From: IAN LAND <iland8@icloud.com> Sent: Sunday, August 23, 2020 7:26 PM To: Sean Mullin <SMullin@losgatosca.gov>; Charlene Land <csland@garlic.com>; IAN LAND <iland\_7@yahoo.com>; IAN LAND <iland8@icloud.com> Subject: Thanks and questions regarding 140 Arroyo Grande

124 Arroyo Grande Way Los Gatos, CA 95032

22 December 2020

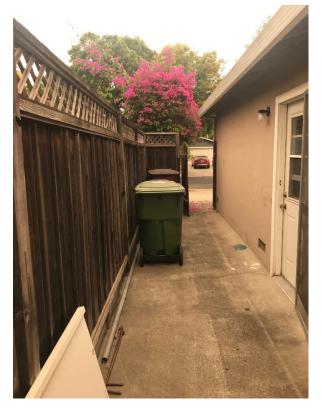
I like attach two photos that show my side adjacent the neighbor.

The first photo: door for going out; garage door with a window, 6' high solid fence topped by 1' non-solid fence.

The second photo: one regular window, one small smoke window, 7' high solid fence.

Chart with additional dwelling size data below – note that 140 Arroyo Grande way is proposed to be substantially above *all* others on a small to mid-size lot with three neighbors

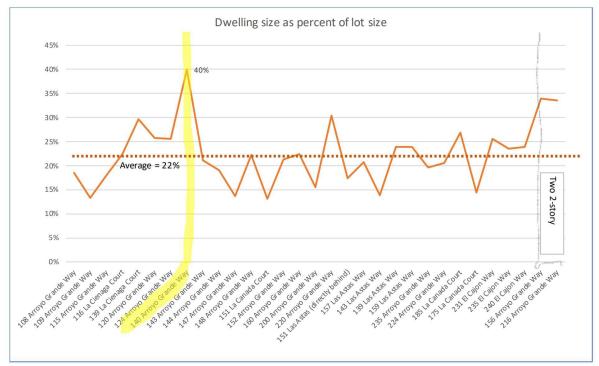
In addition to roof height, the home design proposes the use of 40% of the lot size, more than any of the homes in the proposal data or in the additional data set that is provided below. The average of those 7 homes listed in the proposal data set is 30% with a range of 25 to 34%.
